Fig. 4.—Sectional View of Sawed Block. Note Cavities Under Large Stones Due to Excess of Water

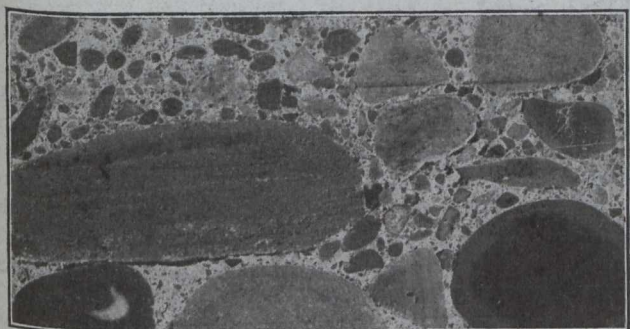
of the six-inch cubes which were tested. The notable feature of this photograph is the large percentage of void space, also the absence of any bond between the mortar and the round pebbles. Both of these conditions result from too much water.

ness, there was a space without any mortar between the stones. It is impossible to go over the pavement and pick out such places, as they are hidden from view. The cause of this trouble is evidently lack of rigid inspection during the laying of the concrete. To illustrate the effect of segregating the large stones a photo (Fig. 3) was taken of the fractured surface of one of the six-inch cubes. This shows the lack of adhesion of the mortar to the stone and also why this cube withstood a lesser stress than the others tested.

4. It is necessary that all concrete should be thoroughly tamped, as the tamping helps to work out any excess water and improves the density and strength of the concrete. Tamping will also help to eliminate the bridging.

6. Nearly all of the defects which have been mentioned in the pavement could have been avoided by rigid inspection during the laying of the concrete. The excess of water, the mixing, the segregation of the stone and the tamping are all defects that a good inspector would never have permitted. The recommendation is made, therefore, that the inspection of all concrete pavements should be systematized and made rigid.
